6627A-07

S E R V I C E N O T E

6627A DC Power Supply

Intermittent Power Transformer “Magma” Connections

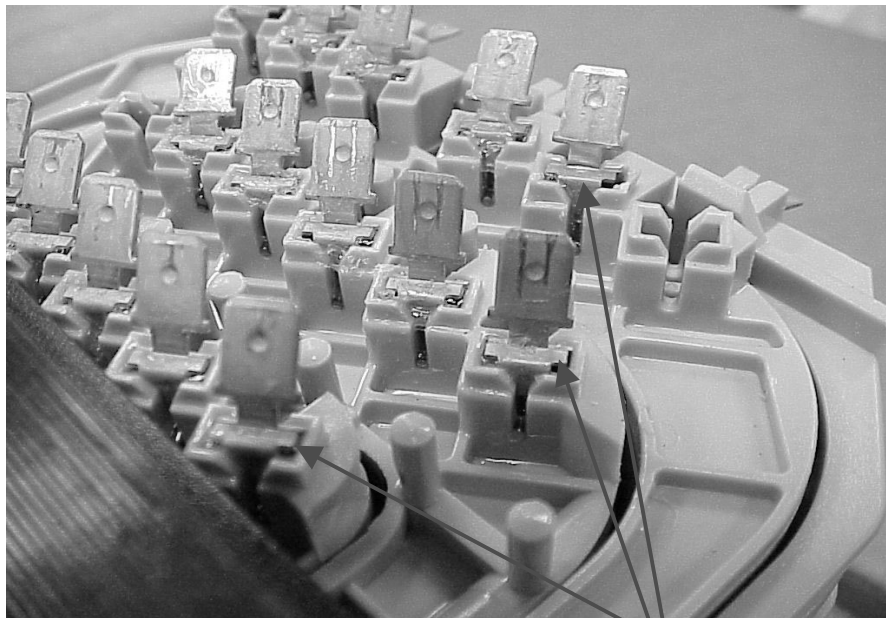
The power transformer vendor mistakenly installed the wrong “Magmates” in a run of power transformers. The incorrect “Magmates” have a # 43 stamped on them, which corresponds to a 15 gauge wire size. The correct size “Magma” should be # 24 designed for a 19 gauge wire size.

Replace the Power Transformer with a new replacement Transformer, see the table above for the correct power transformer part number.

NOTE: Please inspect the new transformer for the correct “Magma” number stamping.

Top View of Power Transformer:

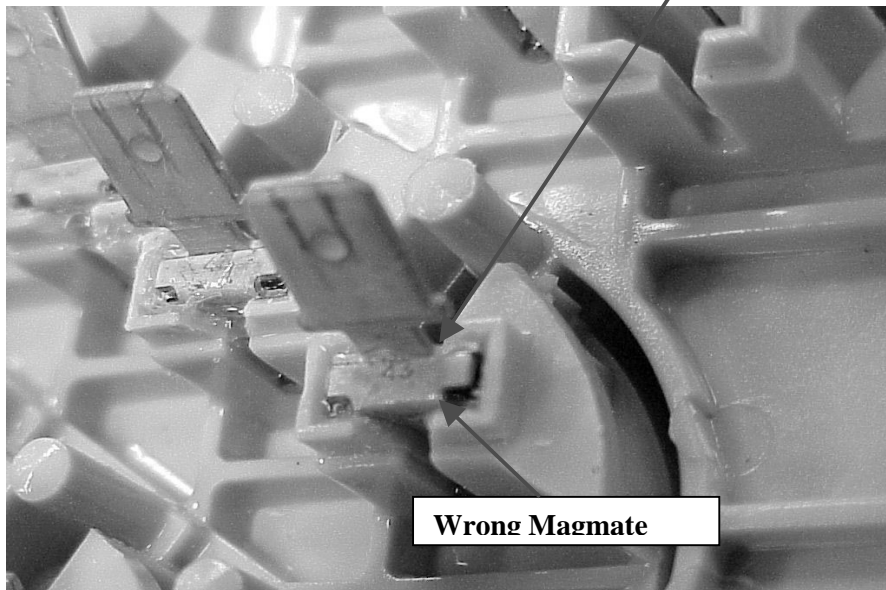
Incorrect “Magma” number 43 on the Surface, This should be number

Wrong Magma
